RE-EVALUATION FORM

Project Name: N / W EXPRESSWAY COURTNEY CAMPBELL N & W TO SR 93

Project Limits: I-275 to SR 597 (Dale Mabry Highway)

Design Change Re-evaluation

Figure 2A Tampa International Airport (TIA) Access Design Change from NB & SB I-275 Express Lanes

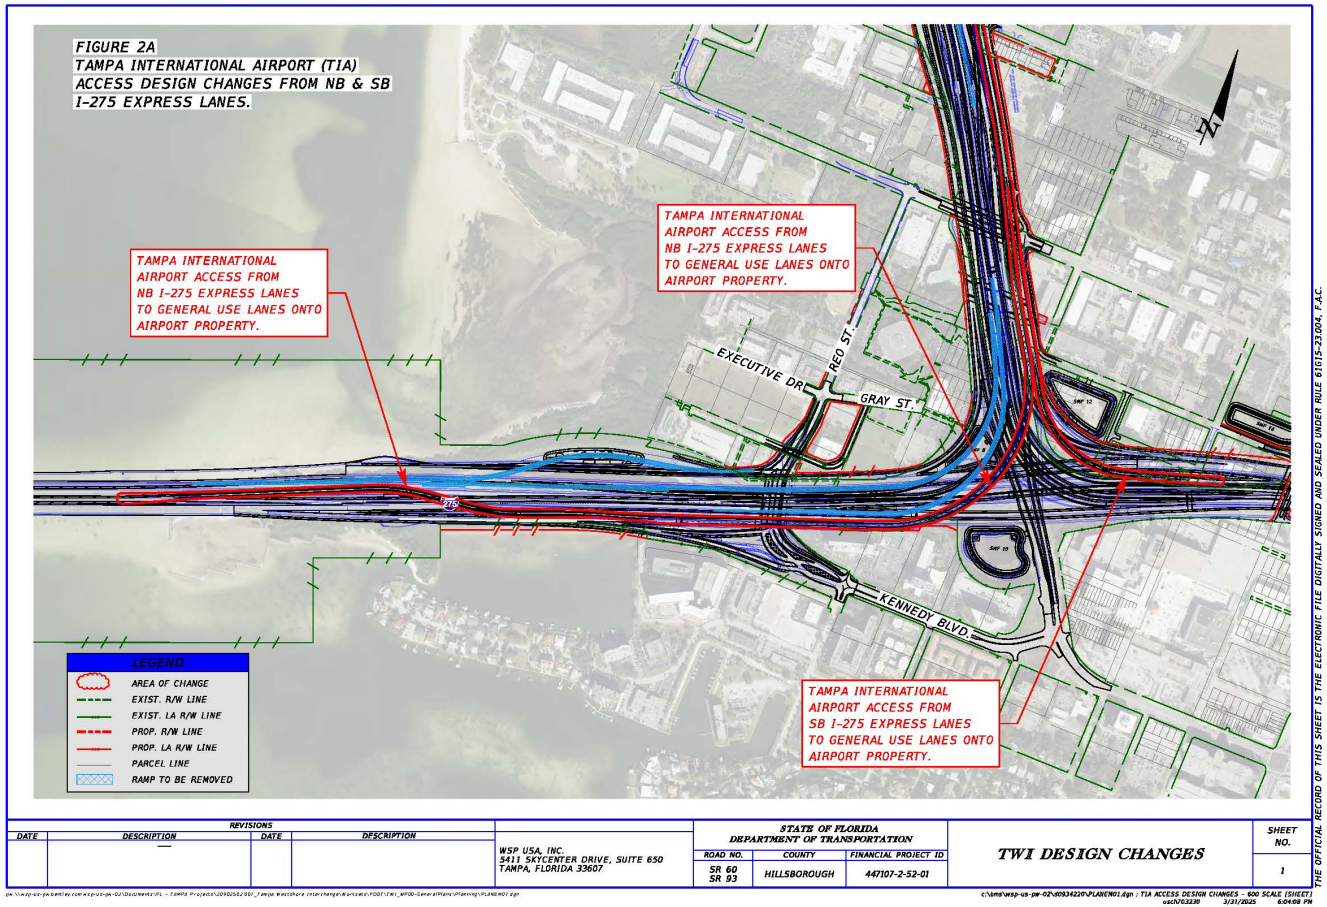
- Access to the airport from the northbound I-275 Express Lanes will be provided via a braided ramp on the I-275 south of the Reo Street Interchange and merge in with the general use traffic heading towards the airport on a 4th level flyover.

- Access to the airport from the southbound I-275 Express Lanes will be provided via a flyover bridge on I-275 just north of the SR 60 Interchange to merge with the general use traffic from I-275 to the airport. These changes are shown in Figure 2A and happens outside of the limits of this study but within the limits of the Tampa Interstate Study (TIS) Supplemental EIS (WPISN 258337-2).

Figure 2B TIA access design change from the I-275 Express Lanes & SR 60 (Memorial Highway/Kennedy Boulevard)

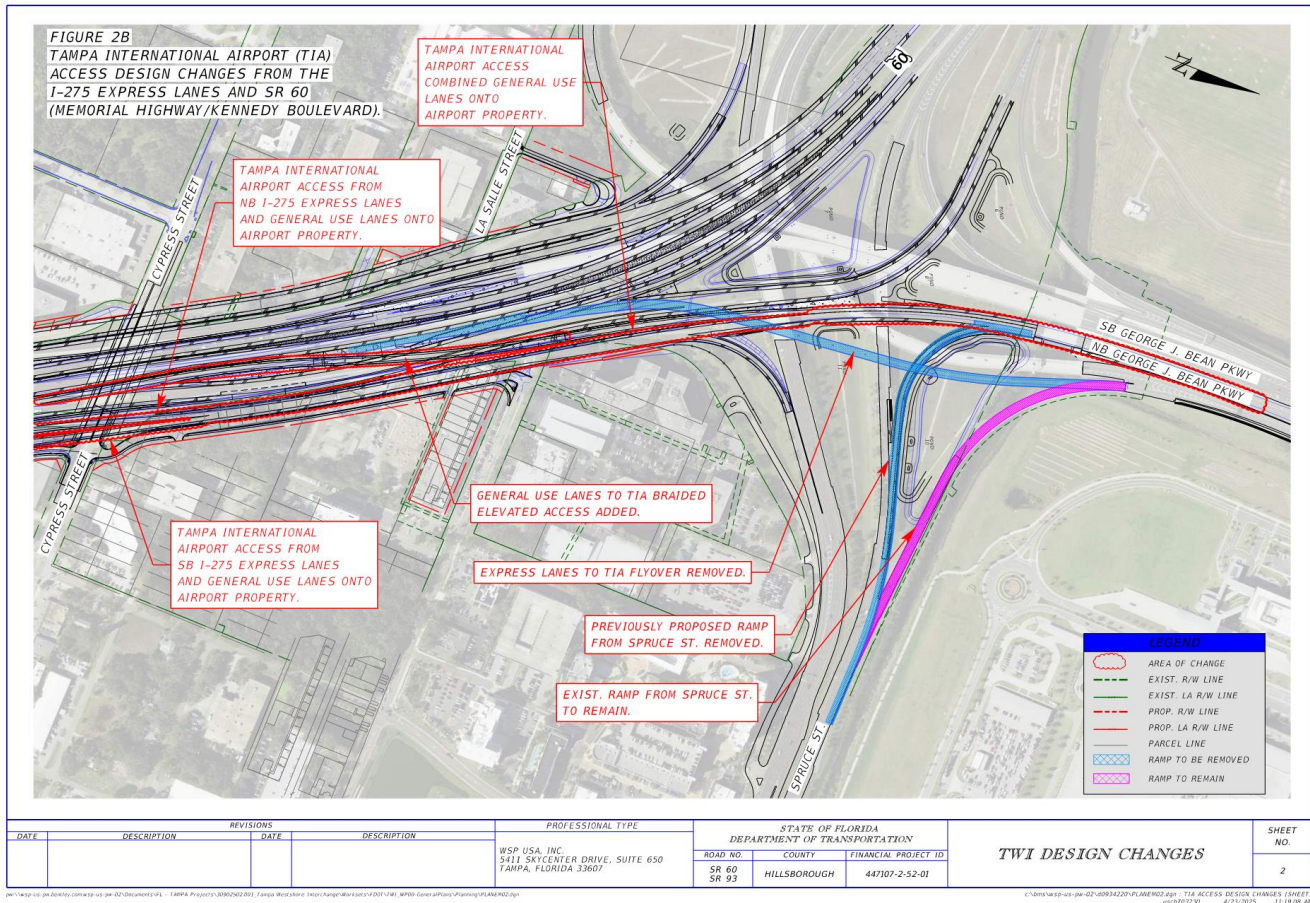
- Access from the westbound SR 60 (Memorial/Kennedy Boulevard) will be provided through an exit on the inside of westbound SR 60 that is located north of I-275 via a braided ramp. Access from the westbound SR 616 (Spruce Street) will remain via the existing ramp. The ramp will no longer be relocated. These changes are shown in Figure 2B.

Figure 3 Airport Operational Improvements

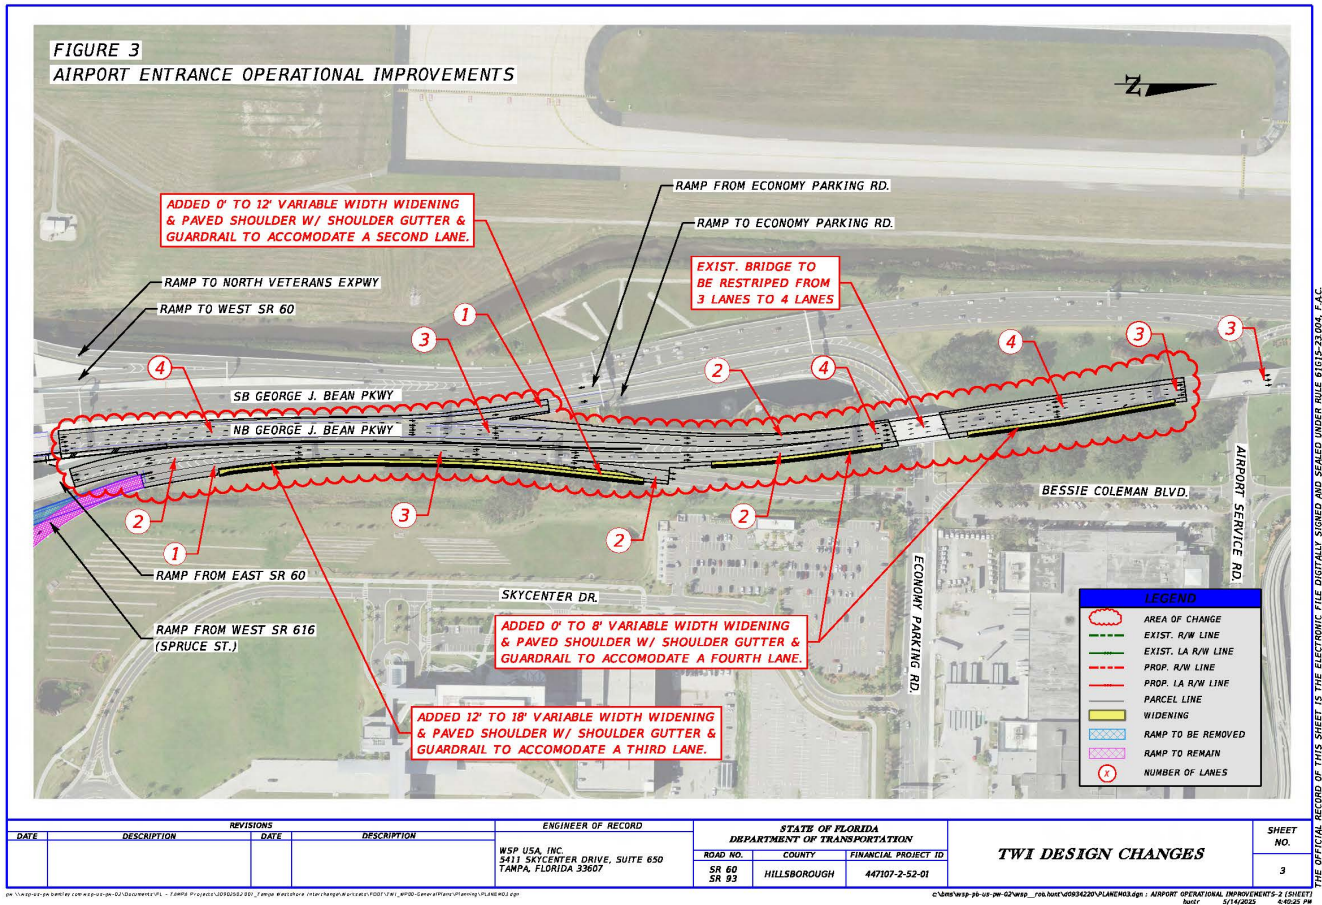
As shown in Figure 3, the design change necessitated the addition of an auxiliary lane to the eastbound SR 60 (Memorial Highway) and the westbound SR 616 (Spruce Street) ramp into TIA via the George J. Bean Parkway.

- The existing ramp from westbound SR 616 (Spruce Street) to TIA merges with the ramp from eastbound SR 60 requiring a variable width widening between 12' and 18' to accommodate an auxiliary lane.
- The ramp that heads towards the economy parking lot from this ramp will also be widened between 0' and 12' to add an additional off ramp lane to the existing two lane ramp onto Bessie Coleman Boulevard.
- Further north of the SR 60/SR 616 ramps merge, the George J. Bean Parkway will be widened between 0' and 8' to accommodate the re-striping for a fourth lane heading towards the airport terminals. This widening will have shoulder gutter and guardrail adjacent to it and will tie into the existing bridge over Economy Parking Road. This design changes will allow better operation to the entrance of the airport.
